Stakeholder Engagement Summary Matrix

Design Concept Alternatives

Lower Cordova Creek Planning Project

June 2021

Pros and Cons

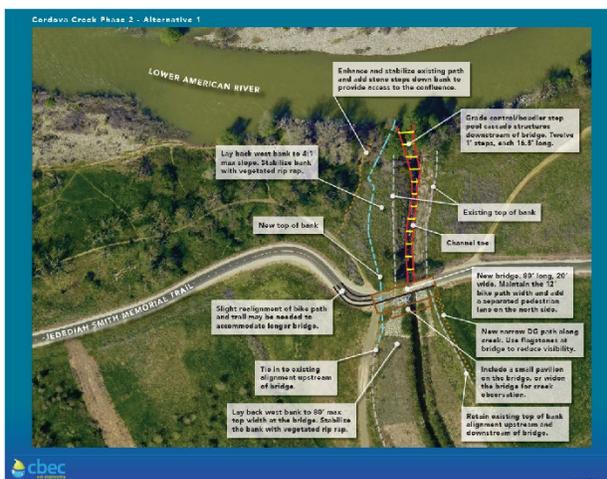
PROS - Ait. 1			CONS - Ait. 1		
Allows for fish passage	Provides access along Ph1 channel	Less disruption to environment	Steeper slope - steps are 1 ft tall	Outlets on the outside of a bend - swifter water and more difficult access for juveniles	Access to confluence - limited landing space
Minimal grading - shares existing channel alignment	Provides access to confluence with LAR	Shares existing East bank - less disruptive to cultural resources	Retains the concrete right bank	Outlet is exposed to swifter river flows	Might it result in stranded redds/ juveniles?
Reduced user conflict on bridge	Provides safe view area of Ph1 channel	Less expensive?	Requires some fill at the downstream end	Requires a bike path encroachment onto Phase 1 restoration	Less trash capture function at high flow events?
PROS - Ait. 2			CONS - Ait. 2		
Allows for fish passage with short 6" steps	Provides access along Ph1 channel	Outlets in an existing eddy - easier access for juveniles	Larger grading footprint and more vegetation impacts	Access to confluence - limited landing space	More expensive?

Reduced user conflict on bridge	Provides access to confluence with LAR	Outlet is tucked behind existing bank protection	Creates a large slope near a bend in the bike trail	Might it result in stranded redds/ juveniles?	Steeper pool area could "tear up" more - square more shads to roof?
Better visibility into the channel	Provides safe view area of Ph1 channel	More surface area for trash capture	Requires a bike path encroachment onto Phase 1 restoration		
Channel confluence is in an existing pool	Greater potential to tie into other restoration project	Easier access for monitoring (less steep)
